Service Information Bulletin

Announcement of released DX-D 100 Version 2.0

This document announces the customer release of the DX-D 100 system version 2.0 in combination with NX Workstation 2.0.8600 / 3.0.8600 and XREDI Software version 10.1.

Figure 2: Example DX-D 10G

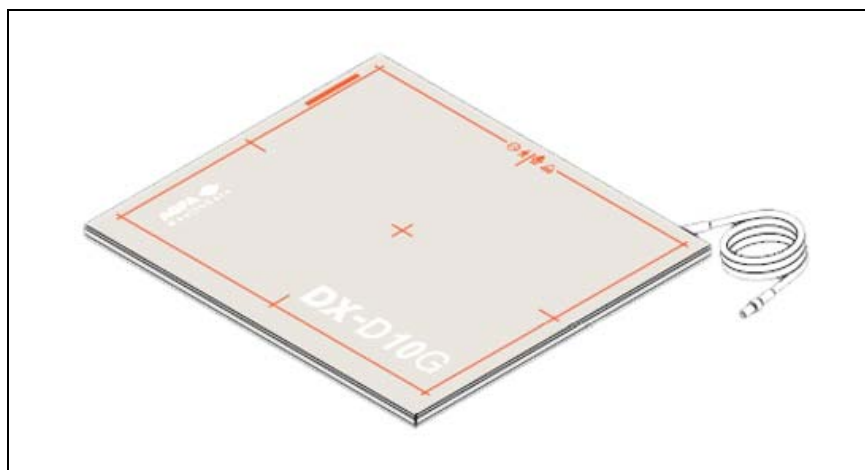
2.2 DX-D 10 C/G Portable DR Detector (Cassette Size Detector)

The DX-D 10 C/G Portable DR Detector is specifically designed for portable applications.

Technical data of the DX-D 10 C/G portable DR Detector:

- DR Detector size: 46 cm x 38.4 cm x 1.5 cm
- Image size: 42.7 x 35.6 cm, 139 μ m-pixel GOS or CSI Flat panel DR Detector
- Pixel matrix: 7.8 Million Pixels (3072 x 2560)
- DR Detector weight: 3.9 kg

Figure 3

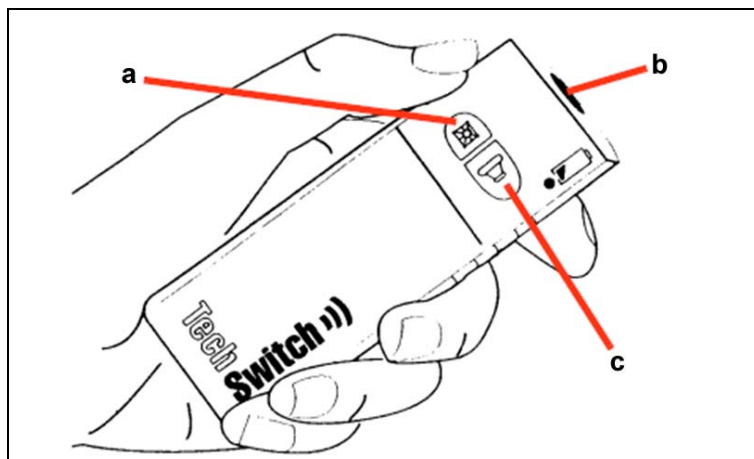
2.6 New Version of Infrared Remote Control available

The infrared remote control of the DX-D 100 consists of:

- Collimator lamp button (a)
- Infrared window (b)
- Exposure button (c)

Symptom The complete functionality of the current released infrared remote control is not given.

Defect The Collimator lamp button (a) has no function.

Solution With the release of DX-D 100 system version 2.0 a new infrared remote control with the complete functionality of all three buttons is released.

Figure 5

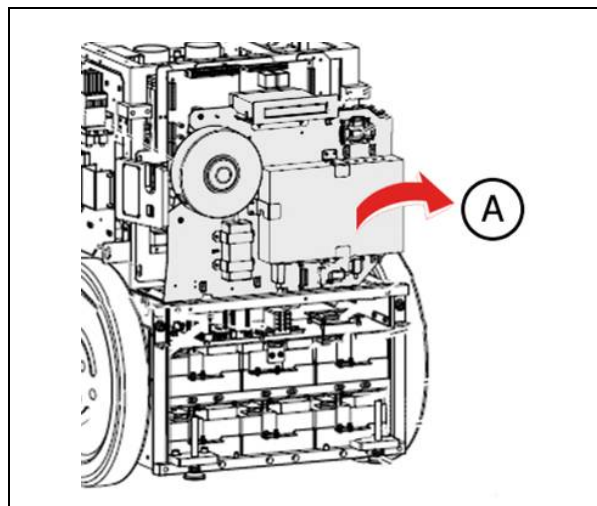
3 Adapted Replacement Instruction of the U24 EPROM on the ATP-Board with the new ELO 17" Touch Screen Monitor

Introduction With the release of the DX-D 100 system version 2.0 the DX-D 100 will be delivered with a 17" Touch screen monitor. This monitor is fixed with a new mounting plate, which affects the replacement instruction of the EPROM on the ATP-Board.

- (4) Open the screws of the rear panel and swing it open (A) as shown in Figure 5.

Figure 7

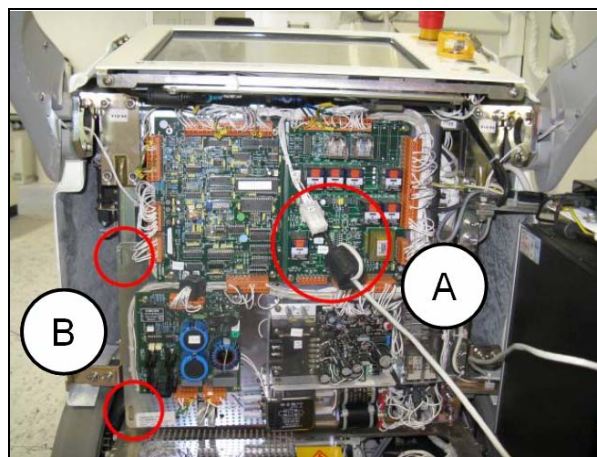
- (7) Disconnect the cable (A).
(8) Open 2 screws (B) of the panel as shown in Figure 7.
(9) Swing the panel open.

Make sure that the cables are not damaged when swinging the panel open.
